PROJECT NAME: Wayne Johnson Community Center Rebuild

SOLICITATION NO: B191051

RE: ADDENDUM #1

ADDENDUM NO. 2

4 COUNTERTOP SECTION
A-902 | 1 1/2"=1'-0"

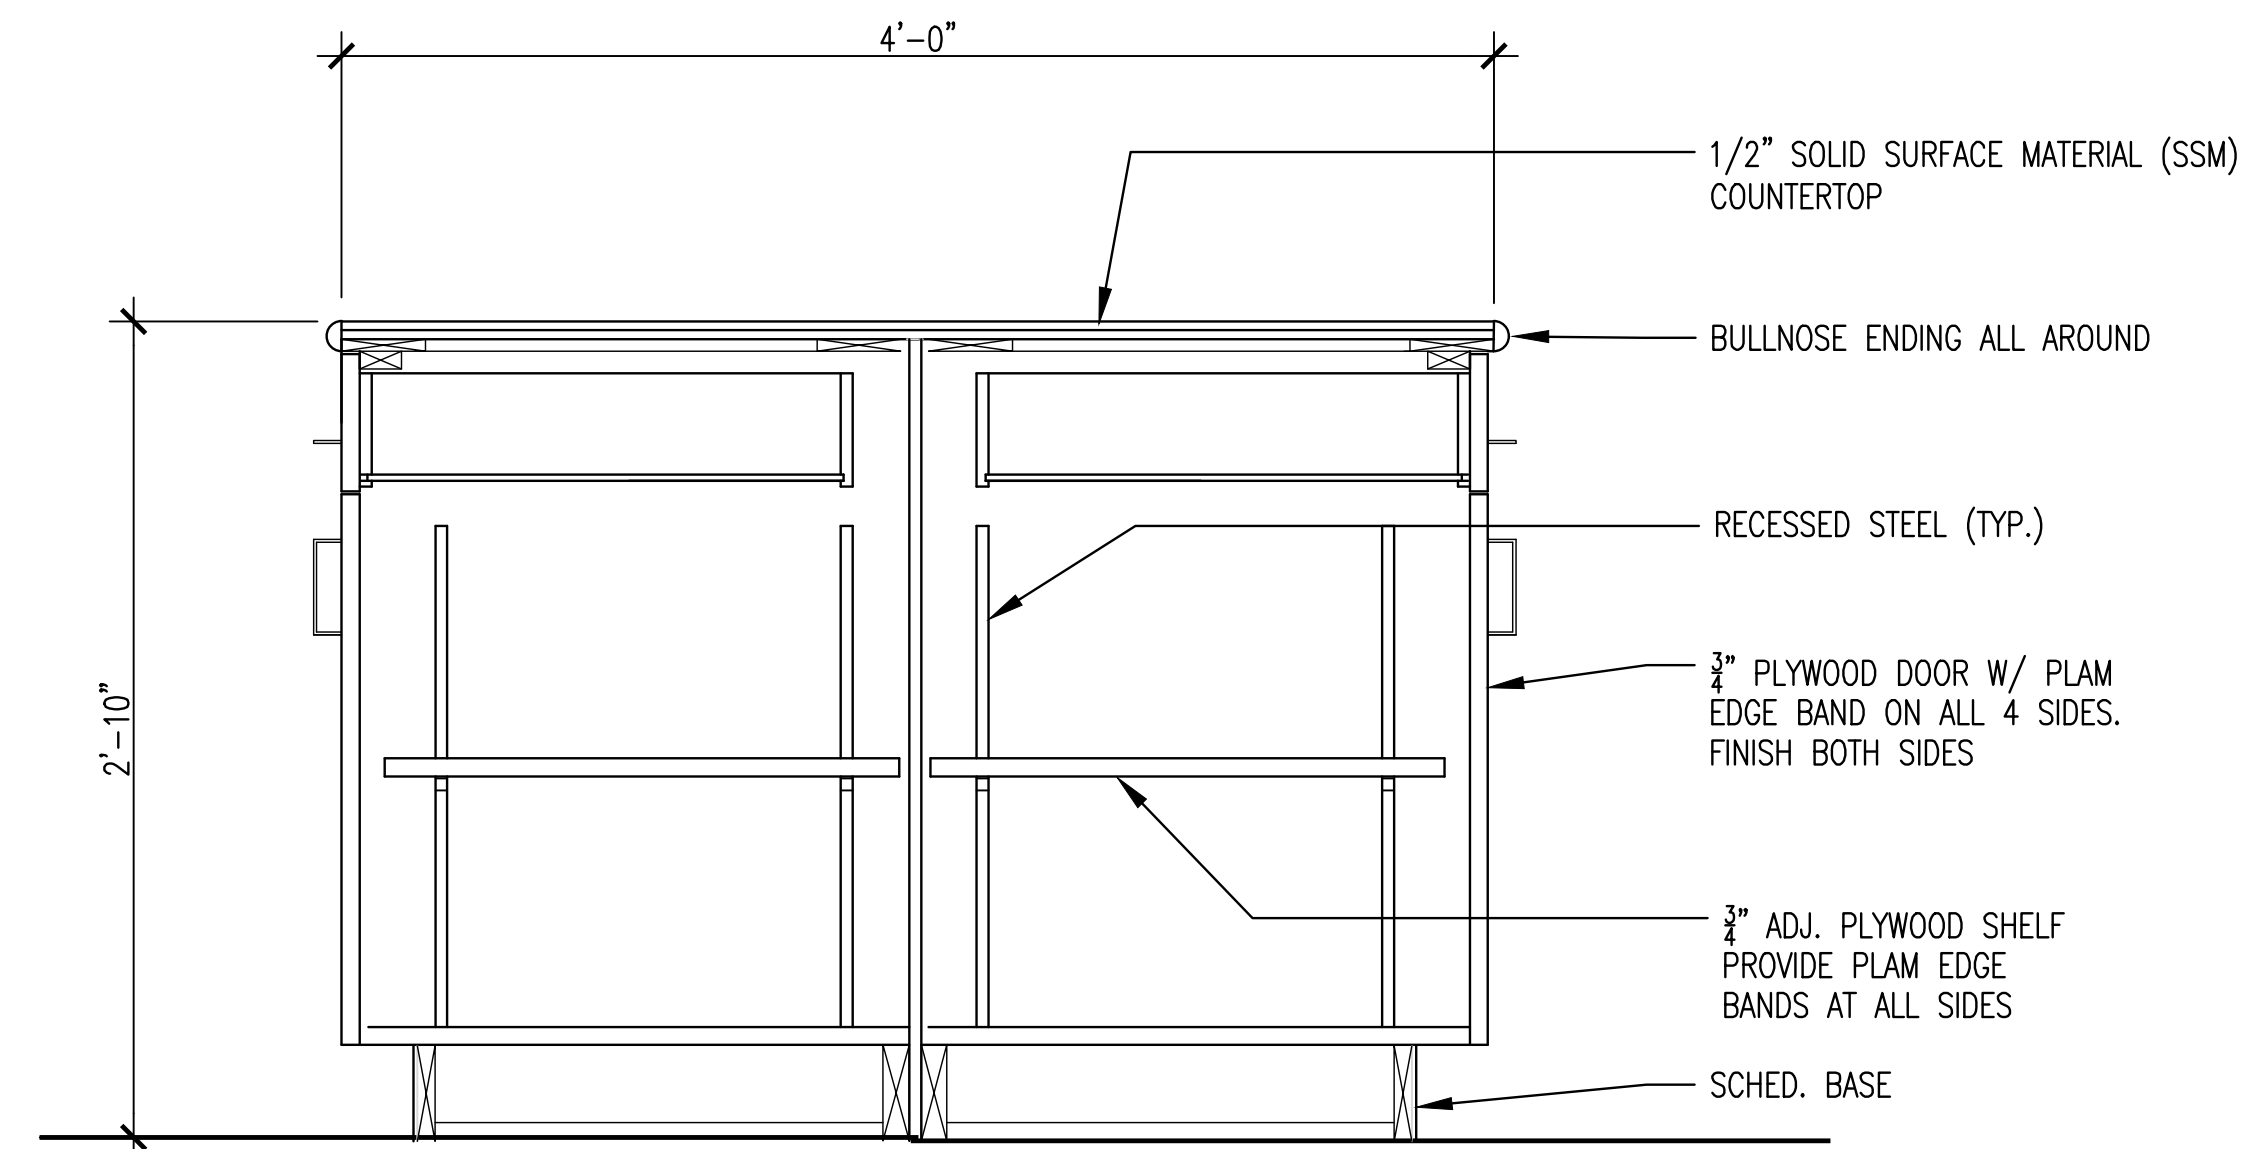
Question #7: *The re-issued drawings indicate a ¼” thick full coverage solid surface backsplash in the breakroom. This is not called out on the Scope of Work document. Do we include this, and if yes, please provide the correct product.*

Response: Yes. Product is specified in Section 064023 Paragraph 2.1.E. Manufacturer: E.1. du Pont Nemours and Company (Corian product) for solid surfacing materials (SSM).

1 LIGHTING PLAN
E-100 1/8" = 1'-0"

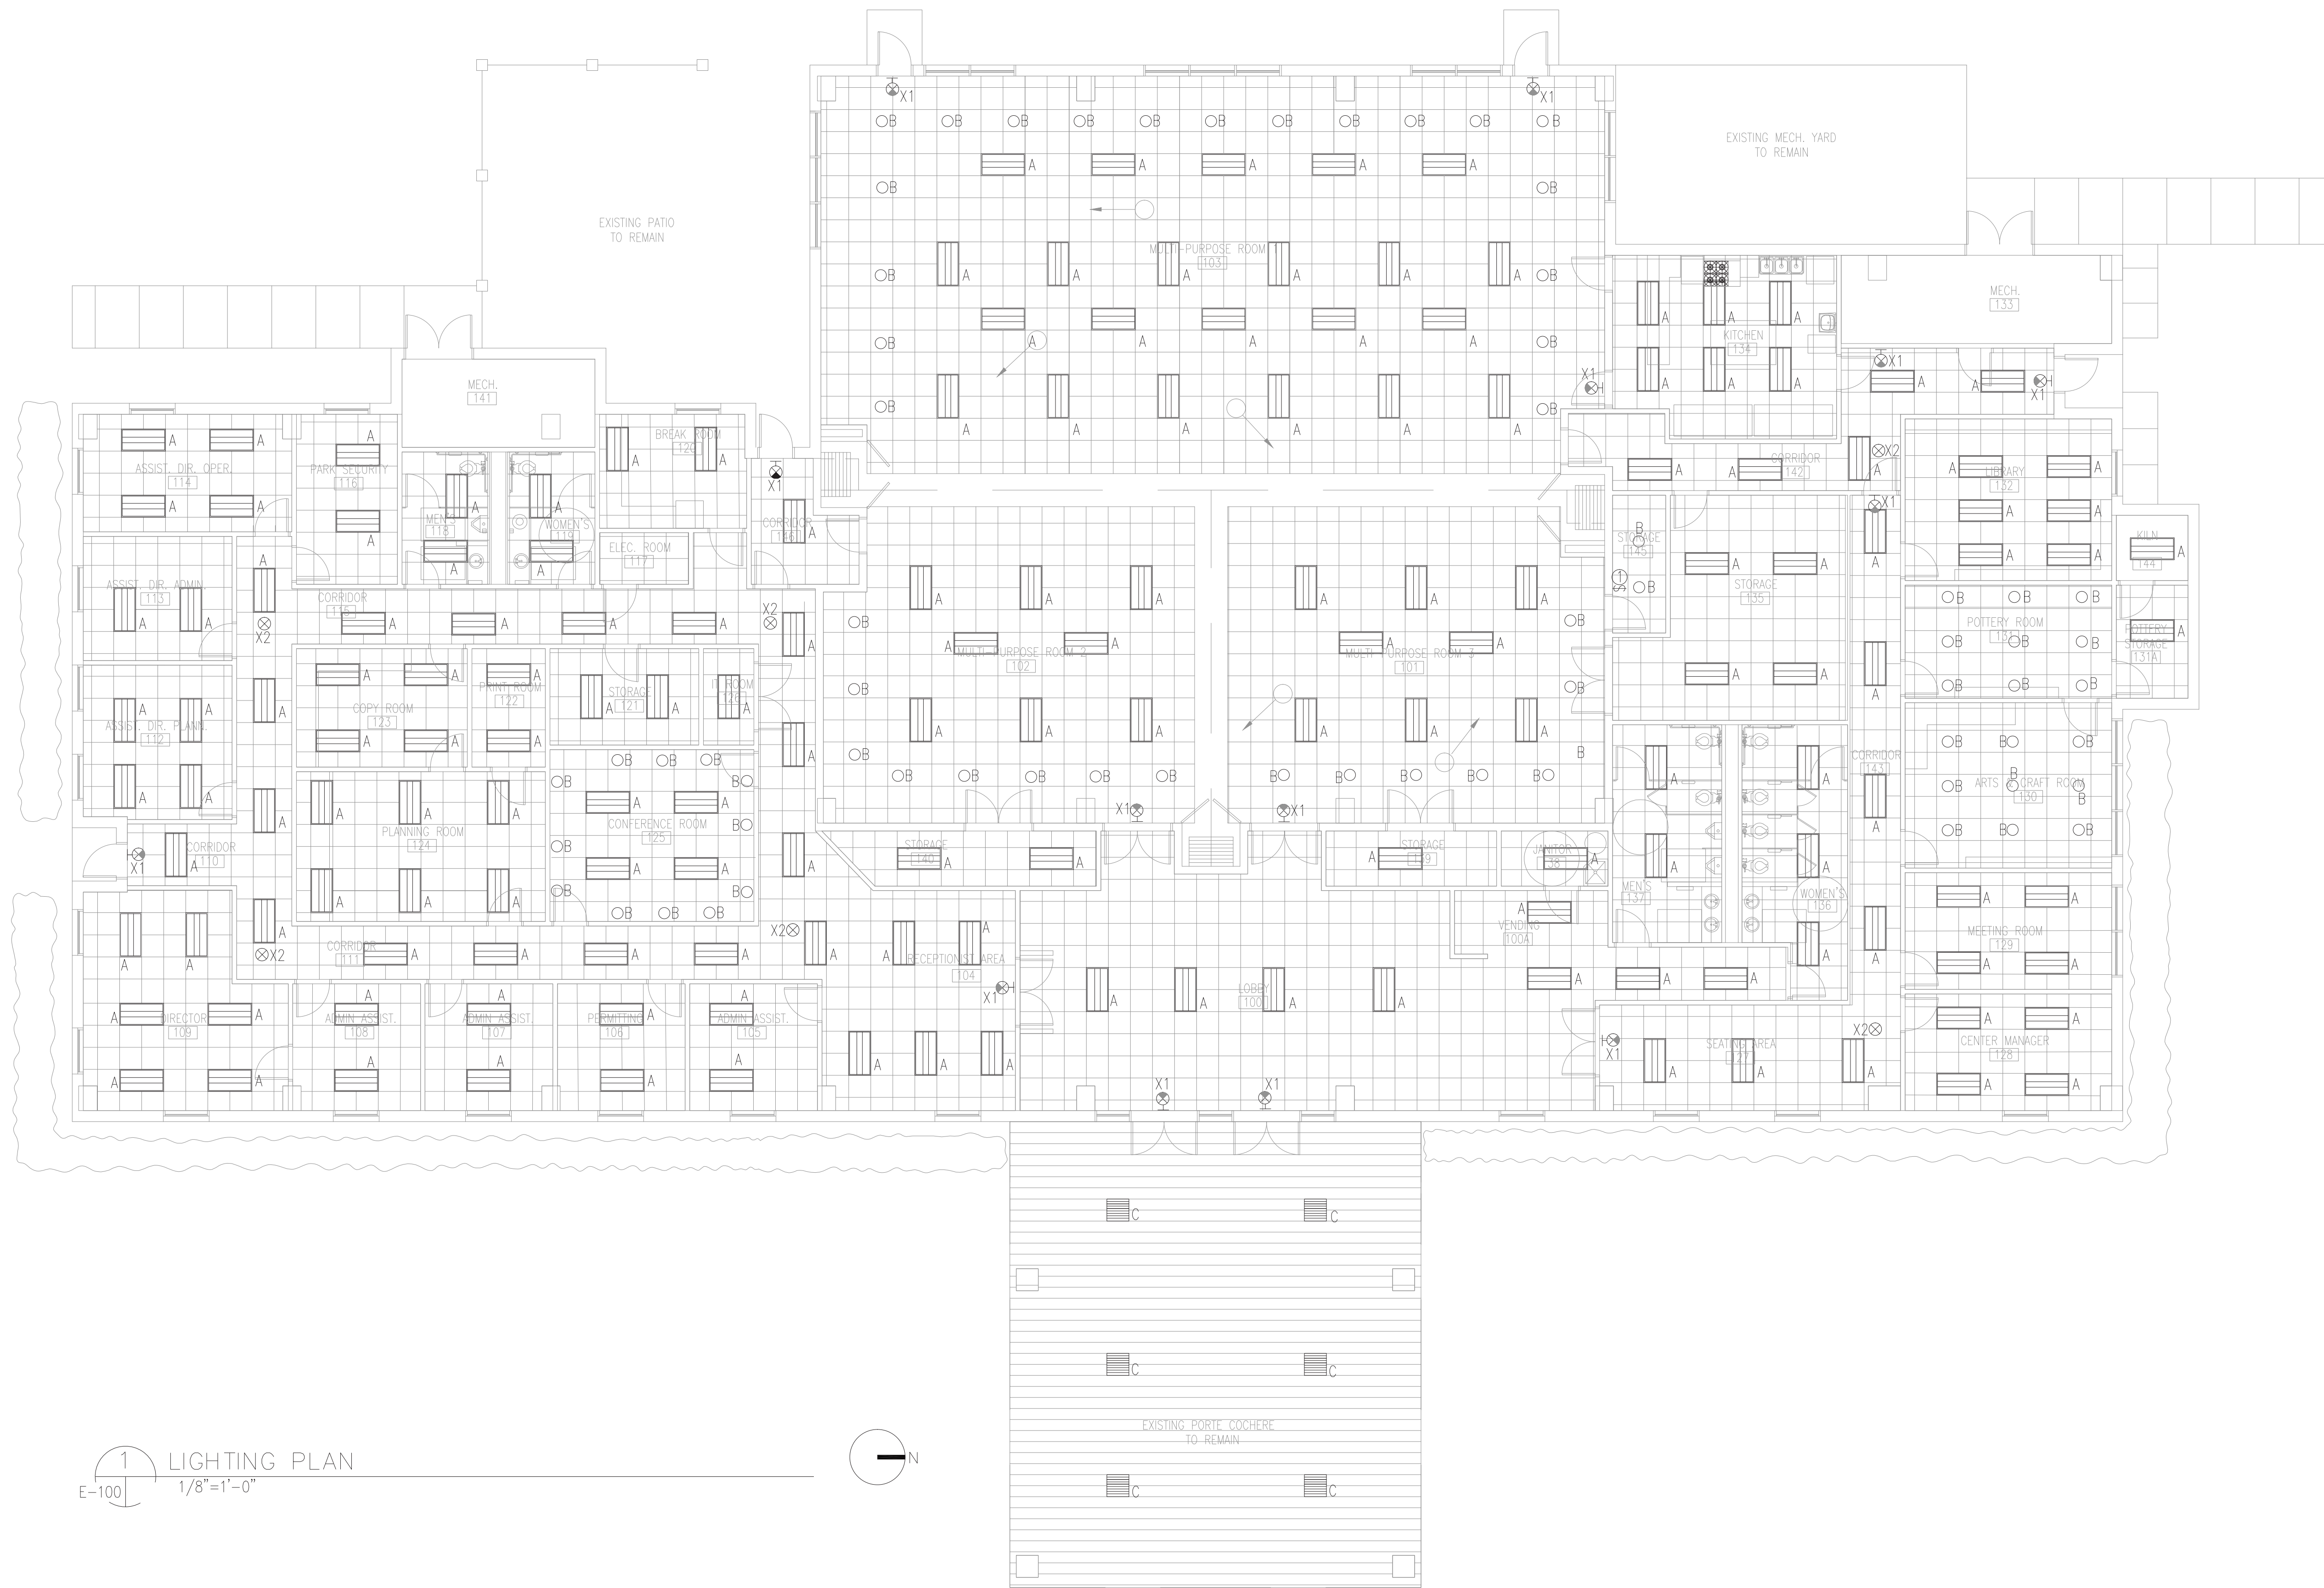
Question #21 *For lighting – is it a requirement to replace the bulbs with LED?*

Response: All new LED light fixtures are to be used. Re: Addendum No. 2 ELECTRICAL drawing.
